# MAJESTIC COMMERCENTER PHASE II

MAJESTIC COMMERCENTER FILING NO. 2  
BUILDING 9 ADDITIONAL PARKING

COVER SHEET & NOTES

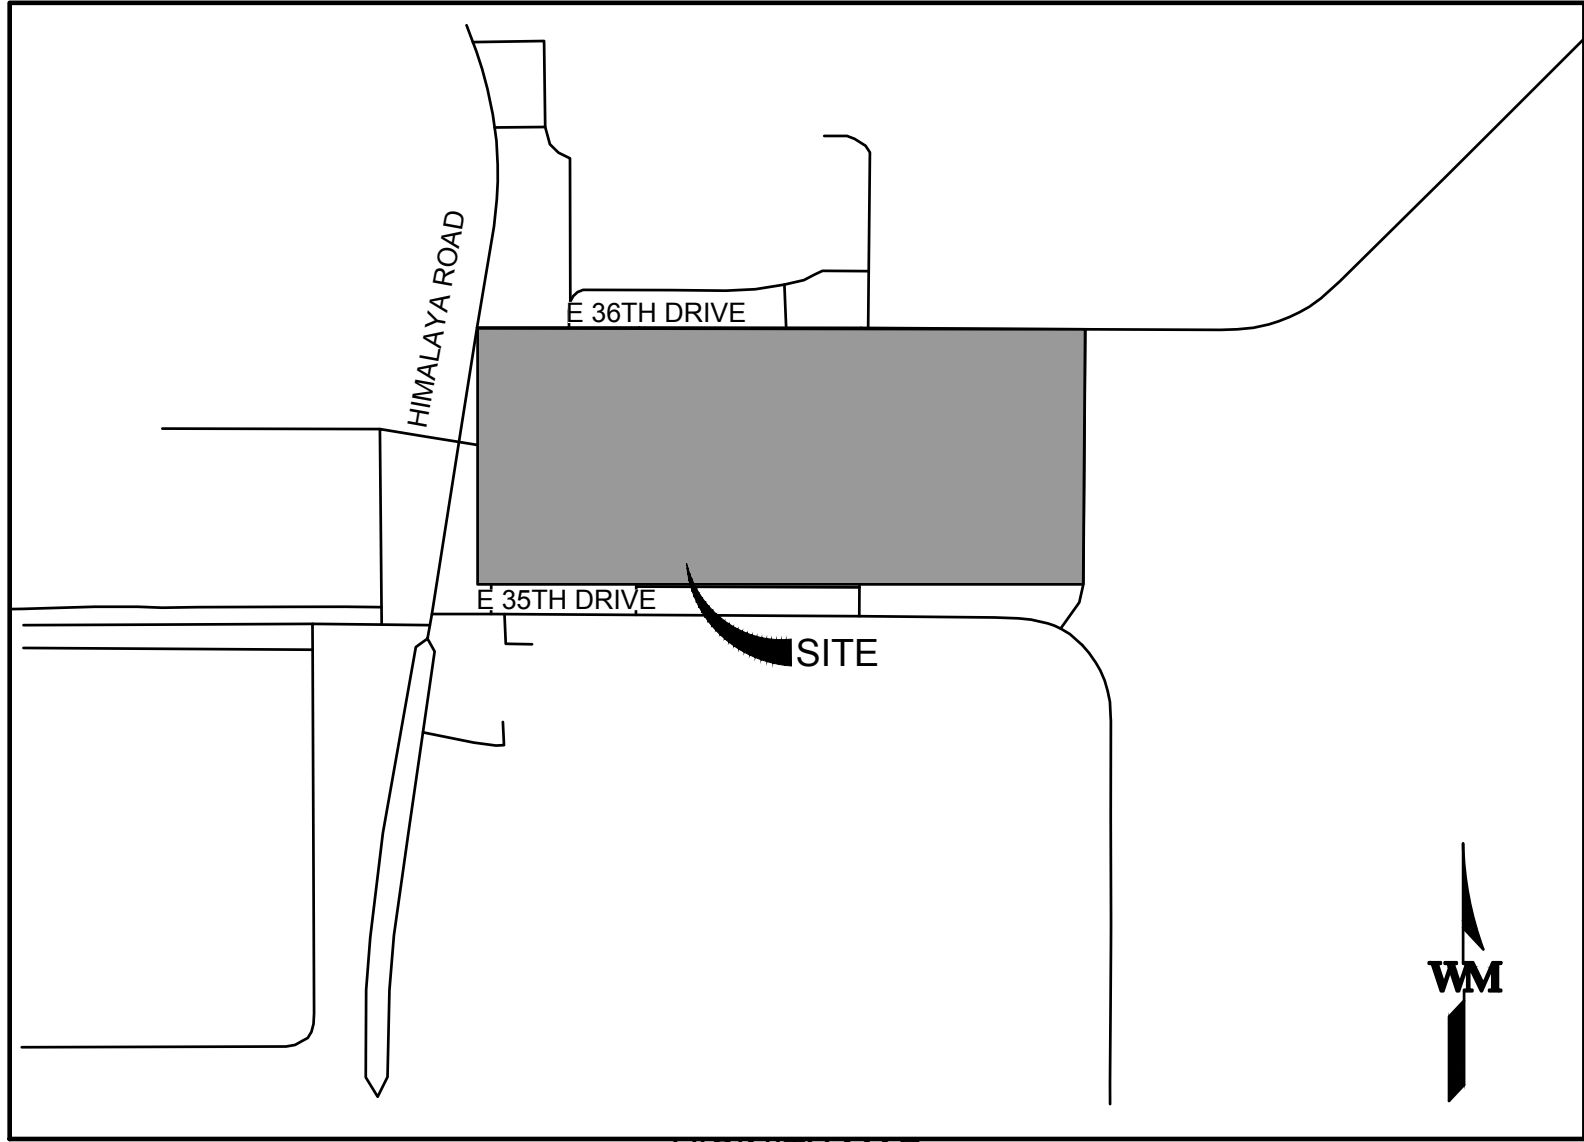
The site plan will not be approved by public works until the preliminary drainage letter/report is approved

Understood

SCALE: 1" = 20'  
GUARD SHACK SITE PLAN  
DETAIL

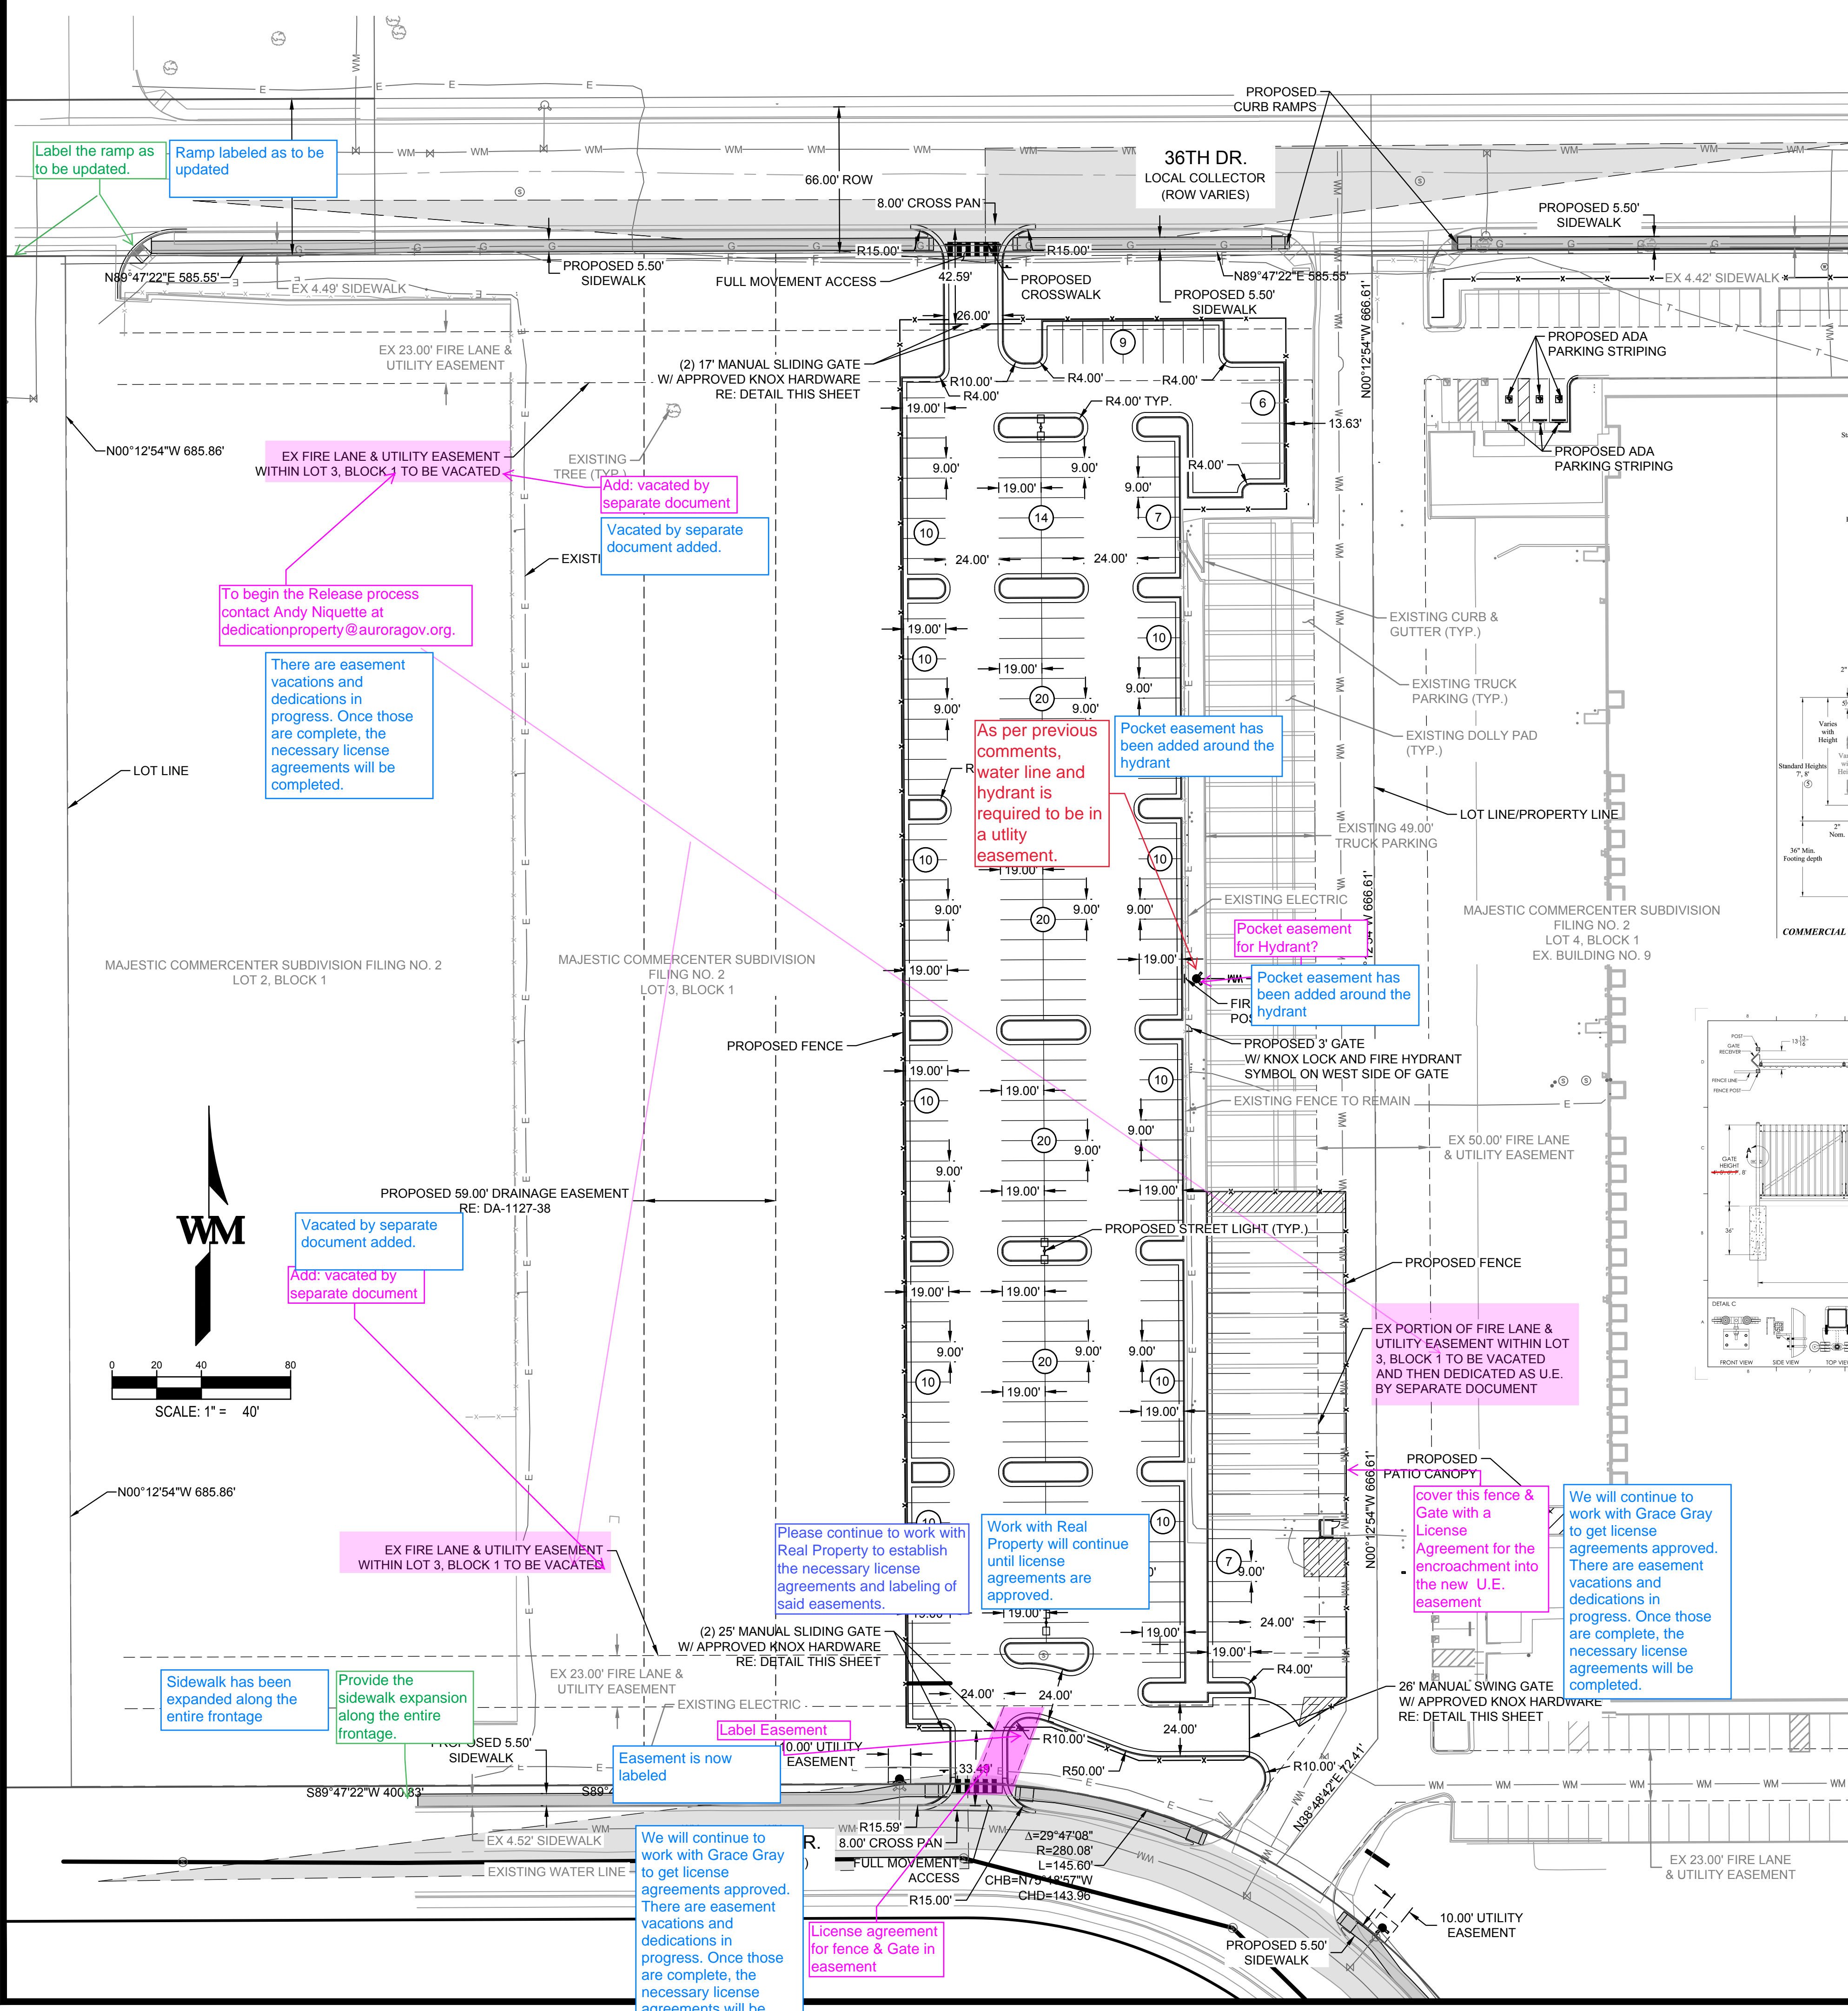
Label the ramp as to be updated.

To begin the Release process contact Andy Niquette at dedicationproperty@auroragov.org.

Add: vacated by separate document

As per previous comments, water line and hydrant is required to be in a utility easement.

Pocket easement for hydrant?

cover this fence & Gate with a License Agreement for the encroachment into the new U.E. easement

Please continue to work with Real Property to establish the necessary license agreements and labeling of said easements.

License agreement for fence & Gate in easement

Add: vacated by separate document

Ramp labeled as to be updated.

There are easement vacations and dedications in progress. Once those are complete, the necessary license agreements will be completed.

Vacated by separate document added.

Pocket easement has been added around the hydrant

Pocket easement has been added around the hydrant

We will continue to work with Grace Gray to get license agreements approved. There are easement vacations and dedications in progress. Once those are complete, the necessary license agreements will be completed.

Work with Real Property will continue until license agreements are approved.

We will continue to work with Grace Gray to get license agreements approved. There are easement vacations and dedications in progress. Once those are complete, the necessary license agreements will be completed.

Vacated by separate document added.

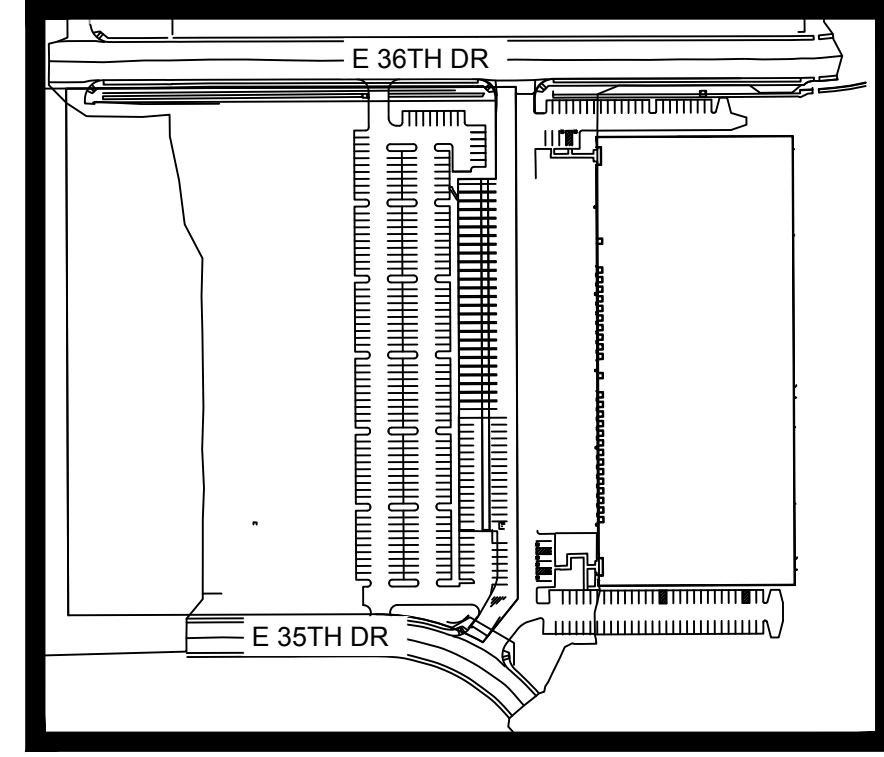
Provide the sidewalk expansion along the entire frontage.

Label Easement

Sidewalk has been expanded along the entire frontage

Easement is now labeled

UTILITY PLAN

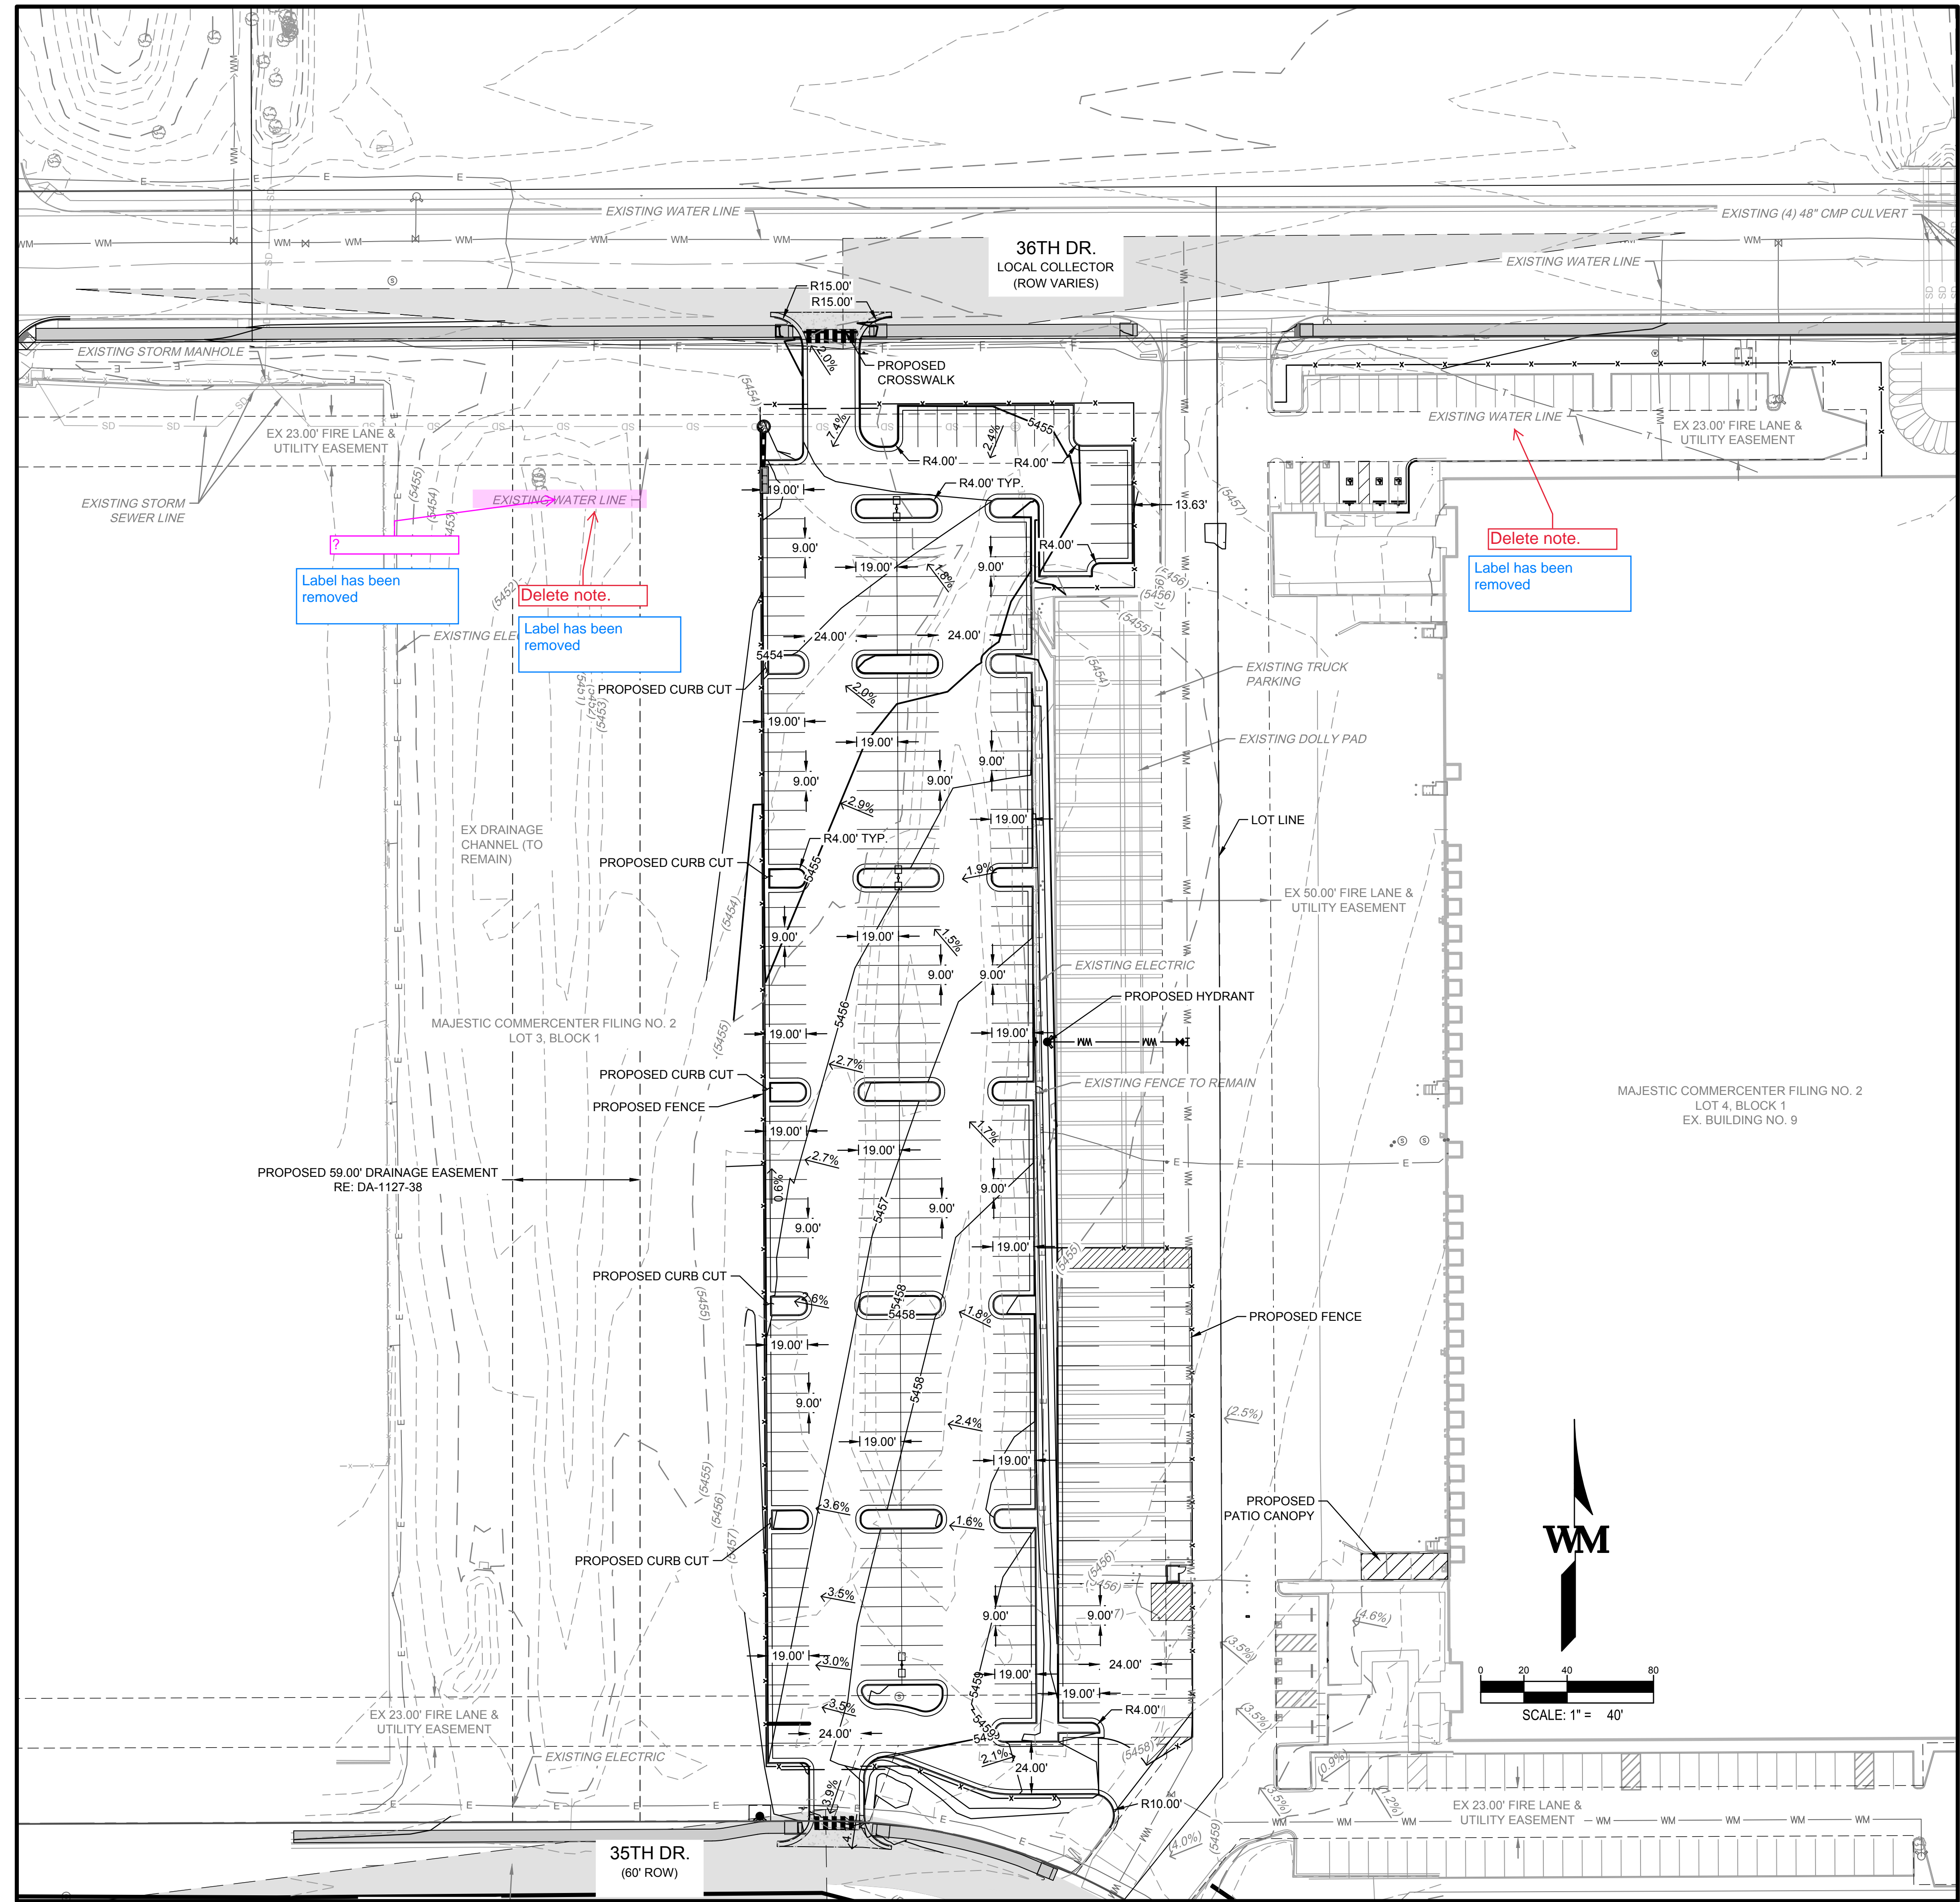
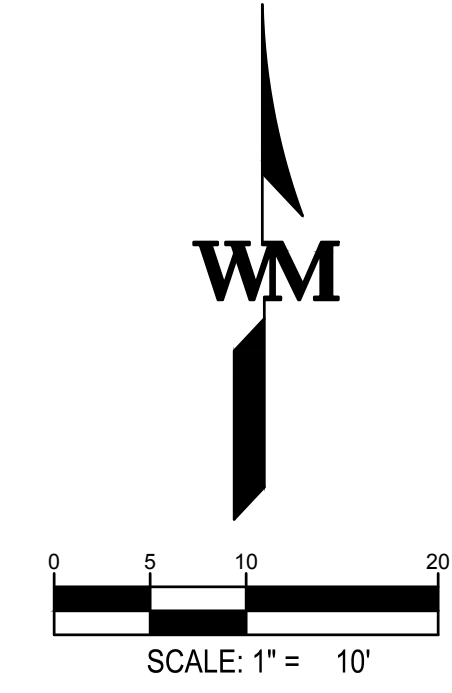
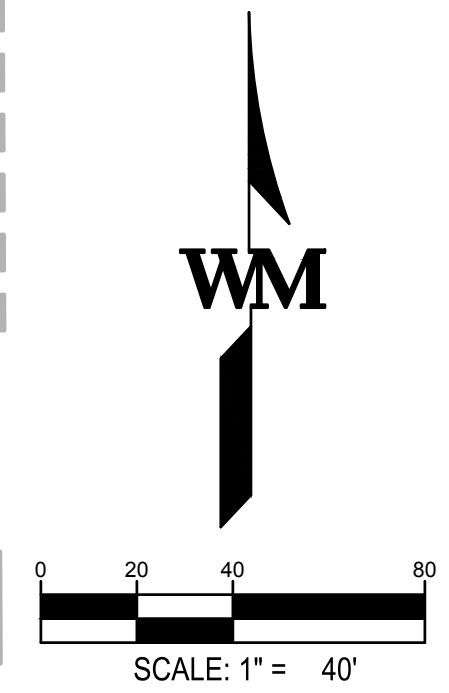
Delete note.  
Label has been removed

Delete note.  
Label has been removed

Label has been removed
